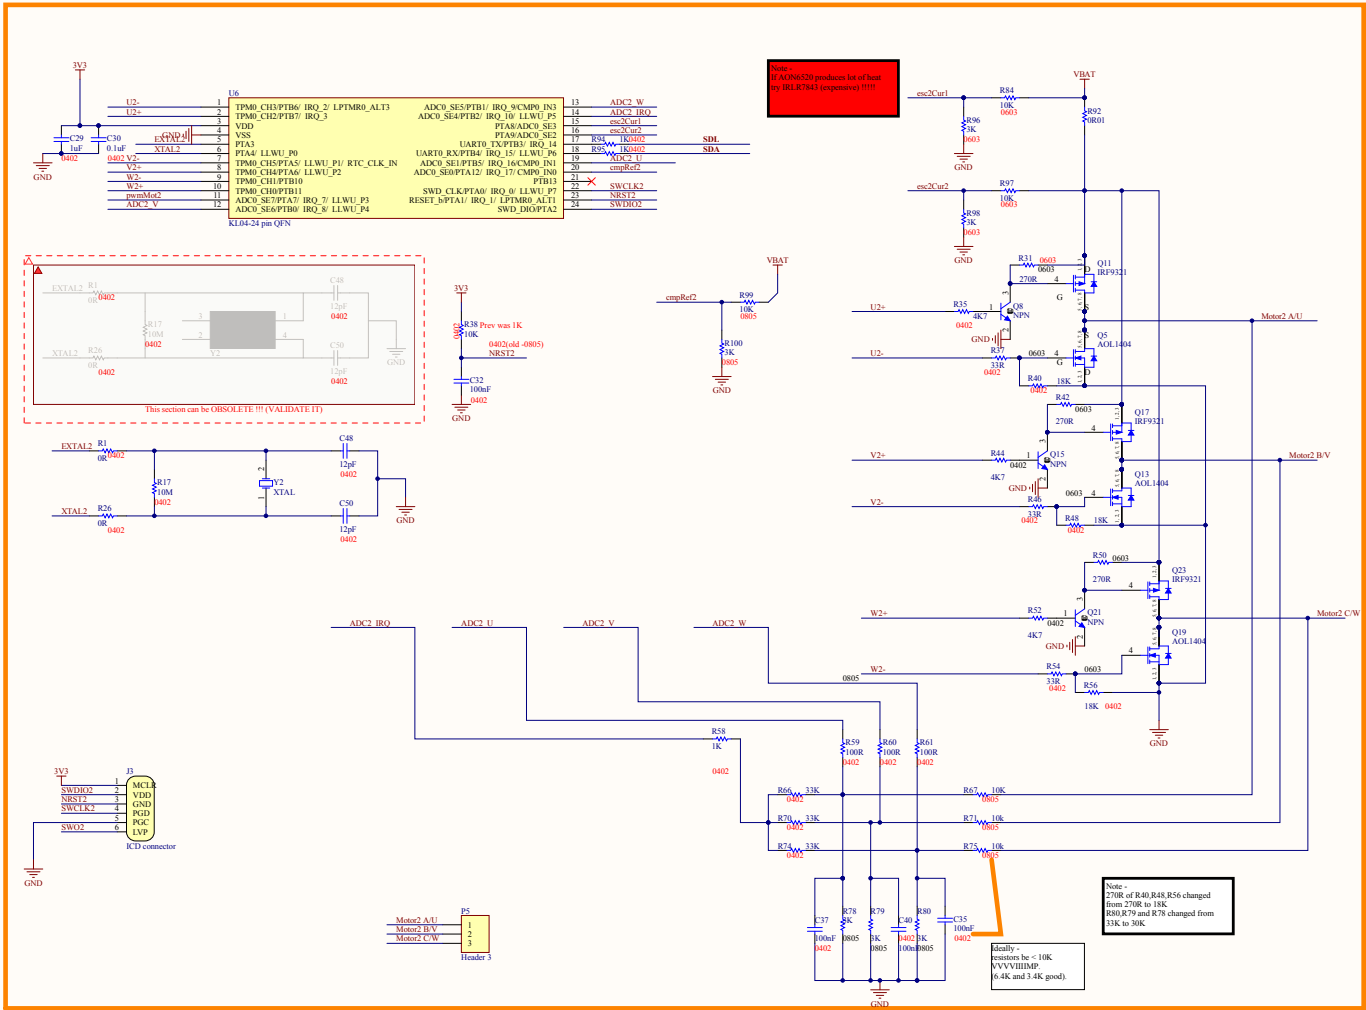
Note:
The lower MOSFETS are changed from A0N620 to A0L1404!!!!
Changed ADC_U and ADC_W to other pins with comp facility. Added a resistor for current measurement as well!!!!

Note:
If A0N620 produces lot of heat try RL187843 (expensive)!!!!
